CITY OF CARMEL-BY-THE-SEA PLANNING COMMISSION

REGULAR MEETING Wednesday, June 14, 2023

CITY OF CARMEL-BY-THE-SEA PLANNING COMMISSION Staff Report

INCREASE OF VIEW FIELD: SECOND PLANNING SUBMITTAL

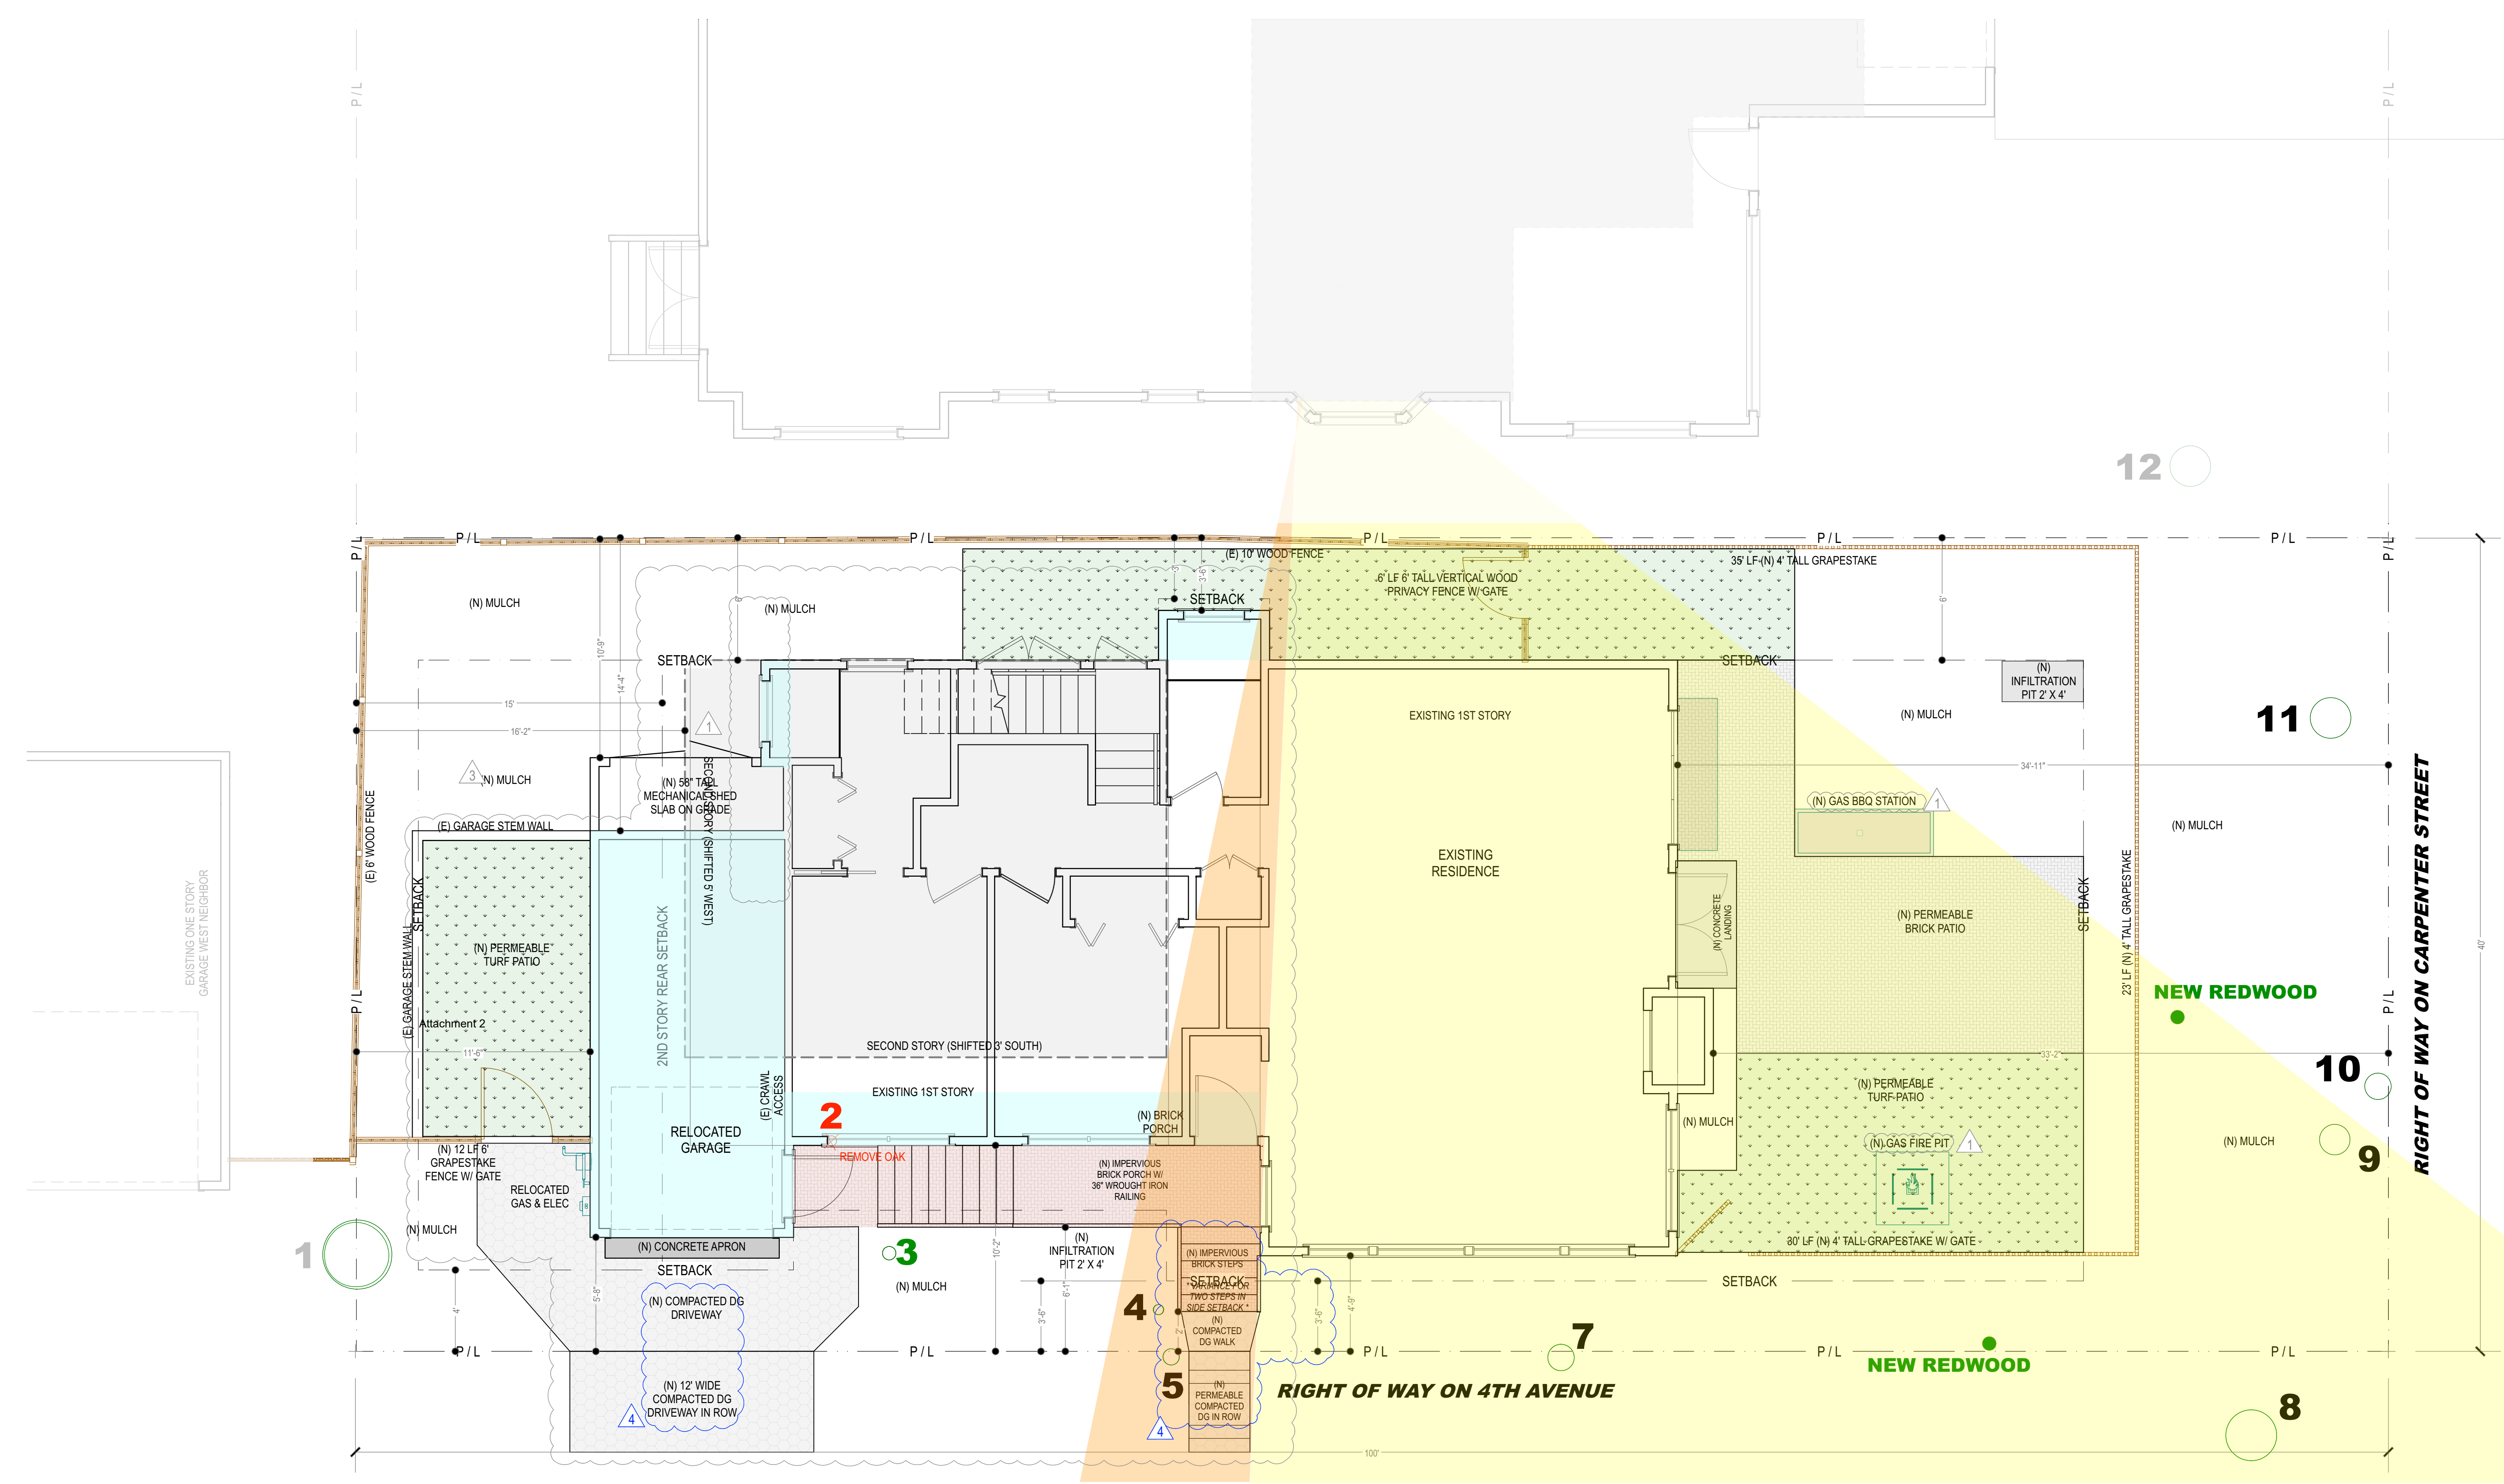
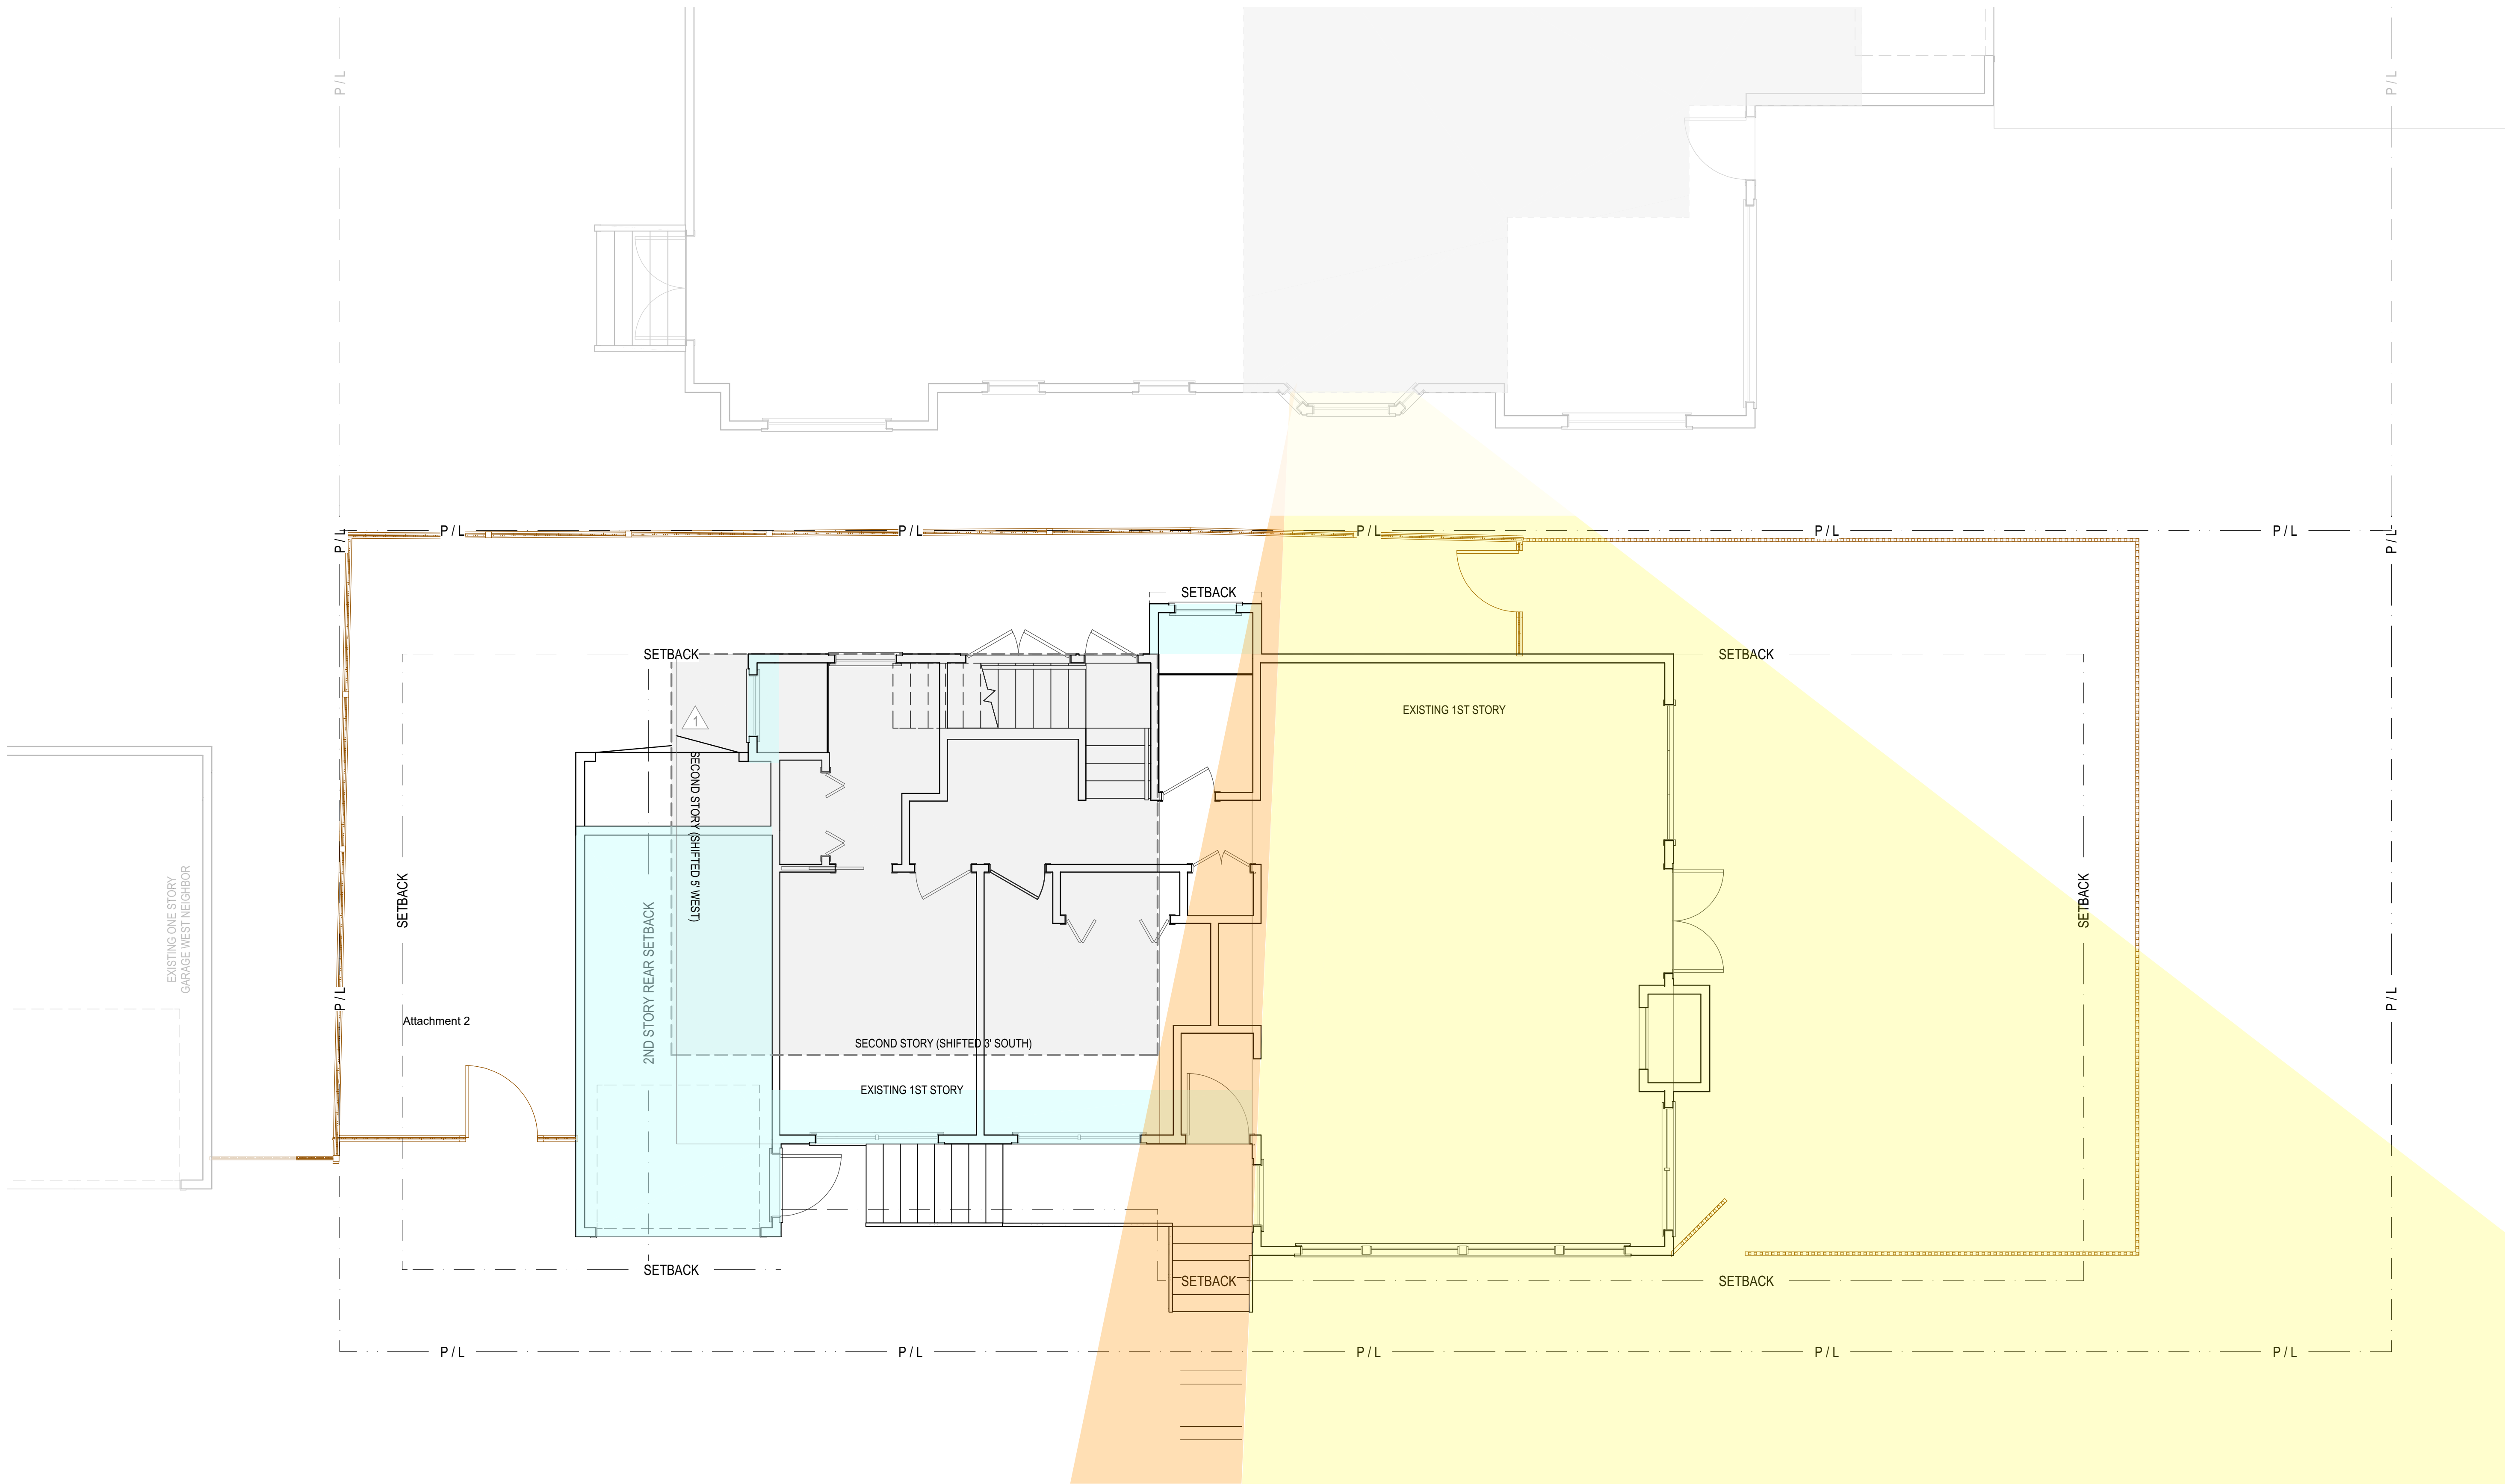
The revised concept design includes shifting the two-story building mass to the south and west to preserve a portion of the existing water view. The applicant has provided a view diagram that compares the view field based on the original design and the revised concept design (refer to Attachment 3, Sheet A-1.3). The changes result in a portion of the existing view being preserved. However, the northern neighbor has expressed concerns that not much has changed, and both views and access to light will still be impacted (Attachment 4).
